UNITED STATES PATENT AND TRADEMARK OFFICE

APPLICATION NO.	FILING DATE	FIRST NAMED INVENTOR	ATTORNEY DOCKET NO.	CONFIRMATION NO.
10/020,275	12/18/2001	Walter Takeo Yagyu	08200.608	9120
7590	05/03/2005		EXAMINER	
Liniak, Berenato, Longacre & White Ste. 240 6550 Rock Spring Drive Bethesda, MD 20817			FERGUSON, MICHAEL P	
			ART UNIT	PAPER NUMBER
			3679

Office Action Summary	Application No.	Applicant(s)	
	10/020,275	YAGYU, WALTER TAKEO	
	Examiner Michael P. Ferguson	Art Unit 3679

DETAILED ACTION

FIG. 6

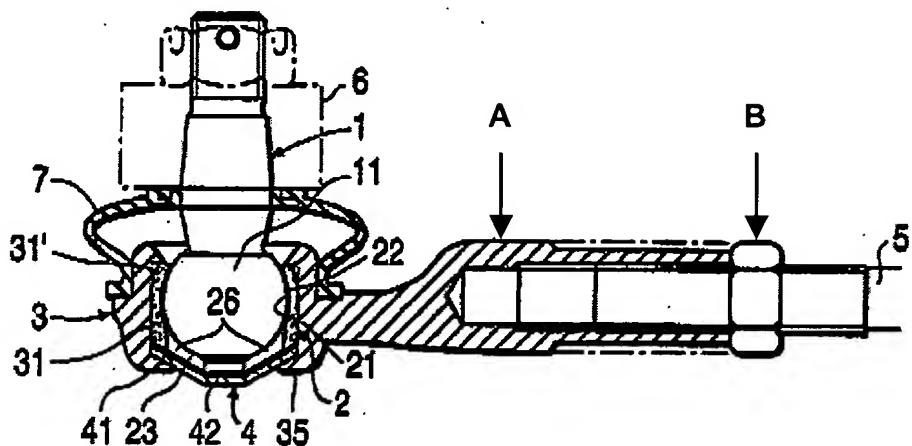
As to claim 1, Shimizu et al. disclose a tie rod comprising a stem 5 provided at its ends with ball joints 3 each composed of a metallic ball joint box A (box A of ball joint 3 has a metallic cross-hatching; Figure 6 reprinted below with annotations), a bearing 2, a protection cover 7 and a ball pin 1, the tie rod having the function of fixing pieces and components of a mechanical system between themselves, providing to them angular and rotational movement, supporting the strains concentrated therein, wherein the stem of the tie rod is combined with components of the metallic ball joint box (Figure 6).

As to claim 3, Shimizu et al. disclose a tie rod wherein ball joints 3 are attached to the ends of a stem 5 by means of a thread on the body of the stem and in the ball joints' boxes A, making the tie rod a tie rod with variable length, the adjustment of its length and the locking of the tie rod being provided by nuts B provided on the threads of the stem and that are tightened against the boxes of the ball joints (Figure 6).
